**HISTORIC LANDMARK COMMISSION
FEBRUARY 27, 2012
APPLICATION FOR A CERTIFICATE OF APPROPRIATENESS
C14H-2007-0023
Walter and Mae Simms House
906 Mariposa Drive**

Reconstruct the existing (failed) stone wall at the southeast corner of the property.

View of the failed section of the stone wall.

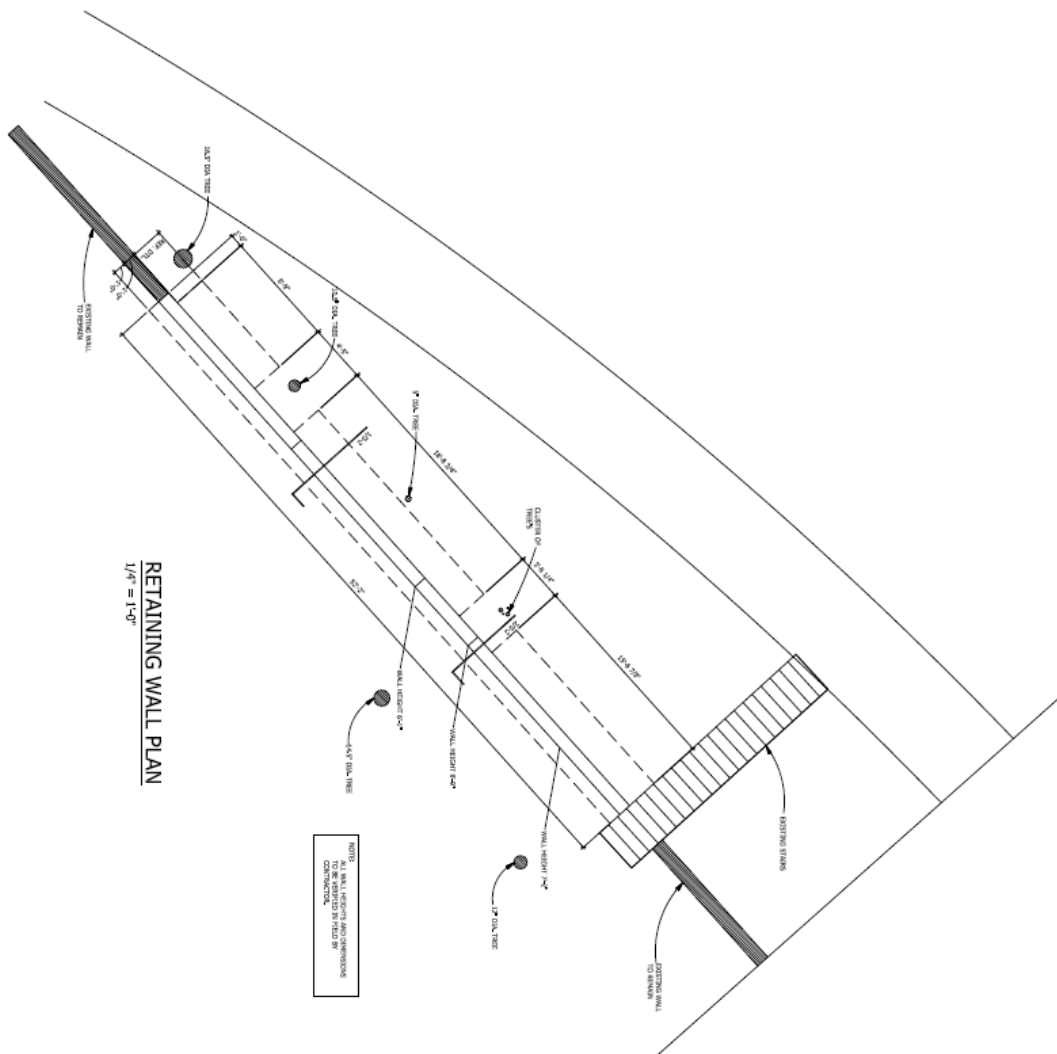
The Committee recommended approval of the application with the conditions that the applicant replace the stones in the same pattern as currently exists, and ensure adequate drainage.

Approve the Certificate of Appropriateness with the Committee's recommendations.
